C6657 Lite EVM Known Issues

Figure 1: Bottom Pads and Bottom Assembly Layer

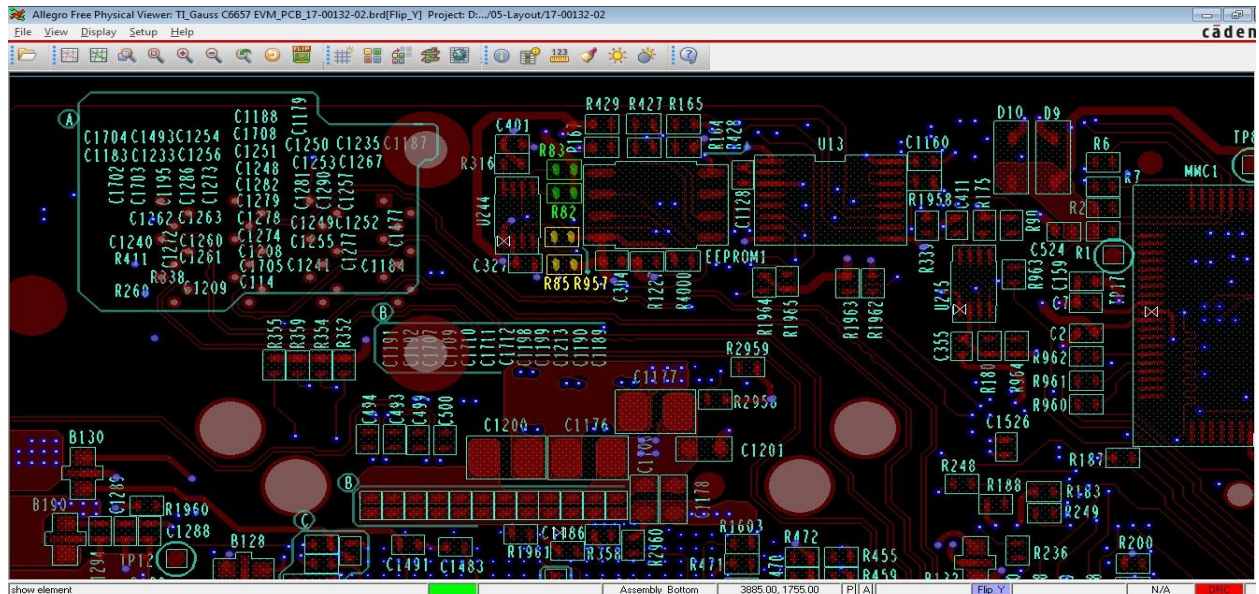
In **all versions** of EVMs, there are chances that the DSP could not read/write Ethernet PHY registers at few random occasions. This problem is more pre-dominant when MDC operated at 1 MHz or higher rate.

Workaround: Please Un-mount resistors R85 and R957 (highlighted below in yellow color). Change resistors R82 and R83 to 10K (highlighted below in green color).
